From: Tom <clbsales@gvtc.com>
Sent: Monday, September 16, 2019 4:19 PM
To: Dale Bickel; Lee Peltzman
Subject: Re: STA requests for k283CJ and K290BV
Attachments: Additional Narrative.pdf

ADDITIONAL DESCRIPTION OF TRANSLATOR STA SITE

The following is applicable to both K290BV and K283CJ.

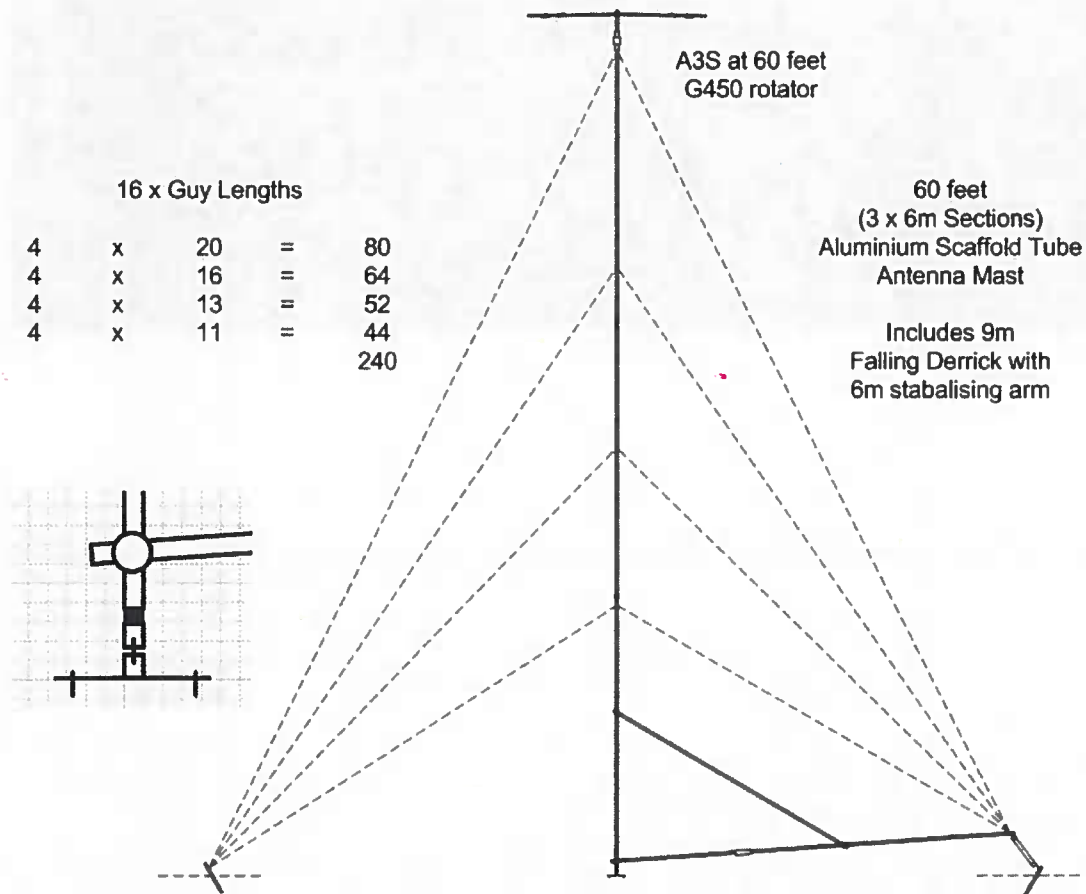
In reviewing these STA requests, I note that the site proposed is a parking area alongside an existing building on Ambler Avenue in Abilene. There does not appear to be any existing structure there capable of supporting the antenna at the 18 meter height requested in the STA requests. Please explain what the supporting structure will be, and provide an antenna sketch that shows the support structure details and the adjacent building height. In addition, please detail how the public will be kept away from the base of the tower. I'm not persuaded that signage will be sufficient for safety.

Drawing of the pole. A3S and G450 rotator will not be used. The expanded drawing lower left is the base of the pole. 4 levels of guys as shown.

Pole and its anchor points.
